STEVAL-CCA044V1 board limitation

Board identification

This errata sheet applies to some samples of the STMicroelectronics STEVAL-CCA044V1, see the below information for details.

Figure 1: Board identification

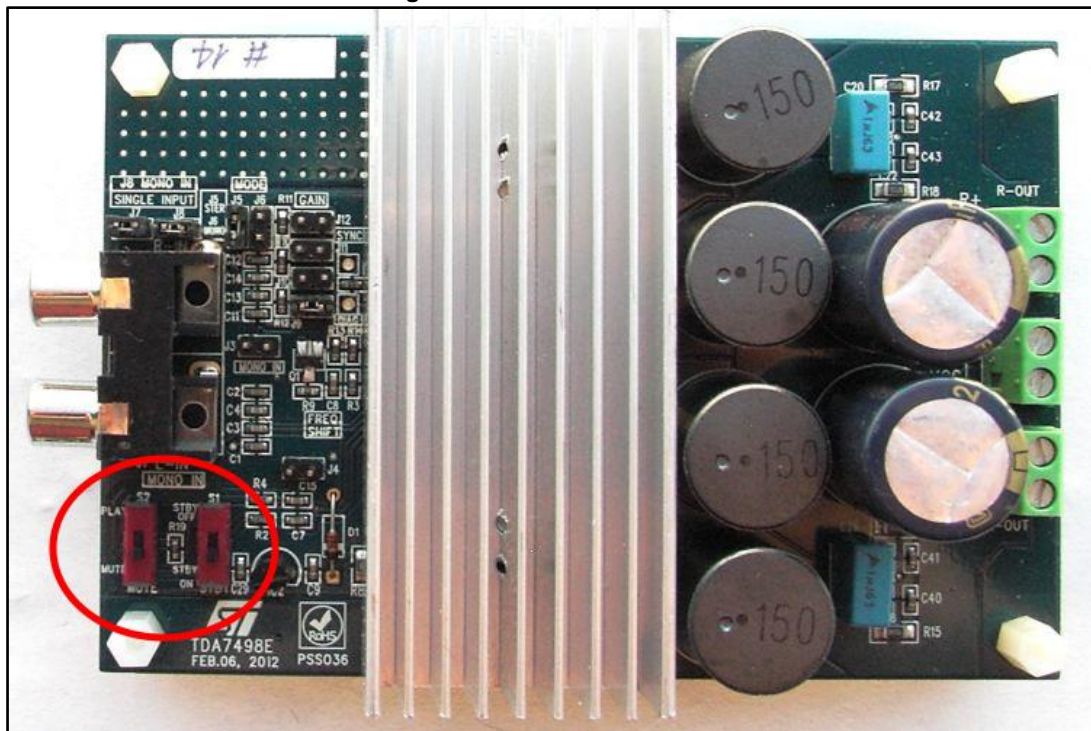
Part number	Device info	
STEVAL-CCA044V1	Error on Silkscreen (see Figure 1), if it is indicated:	
	PLAY	STBY OFF
	MUTE	STBY ON
	With this order

See the circle

These boards have an errata silkscreen, the correct one is:

MUTE	STBY ON
PLAY	STBY OFF

Use the switch in opposite way.
